COUNCIL AGENDA REPORT

SUBJECT: Appeal Of Architectural Board Of Review Project Design Approval Of A New Seven-Unit Apartment Building At 1818 Castillo Street

1818 Castillo St. Apartments
 1818 Castillo St.

Site Plan

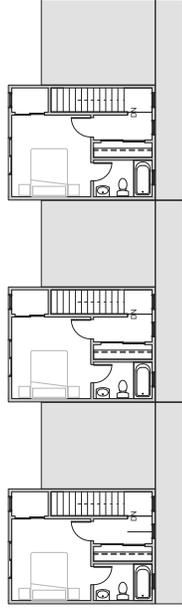
The appellant asserts that there is no on-site turnaround for vehicles including guest, delivery and emergency vehicles, thus making it necessary for these vehicles to back-out on to the street, which is contrary to existing City guidelines. Transportation Division staff reviewed the proposed project for compliance with the City's Standards for Parking Design and found the project to comply with the minimum distance necessary for a vehicle to enter each of the garages in one forward movement and to exit each of the garages and property in one backward and one forward movement. Projects developed under the AUD ordinance are not required to provide on-site guest parking; therefore, the vehicular access is intended for the residents of the property and additional on-site turnaround and parking was not required.

1. There is no automobile turn-around on-site which thus necessitates that every car that cannot nose into a garage will have to back out onto busy Castillo St. Back-outs are contrary to current City transportation department design guidelines. (Arguments by the designer that each tenant has a garage to turn around in does not address the common daily occurrence of entry by guests, emergency vehicles, delivery trucks, etc. that will come and go on a regular basis)

- ◆ Design & Ordinance Requirements met
 - 7 spaces (min. 1/per unit)
 - No guest parking required
 - Min. distance for garage turnaround
 - Min. garage dimensions
- ◆ Garages required for off-street parking
 - Violations enforced on complaint basis
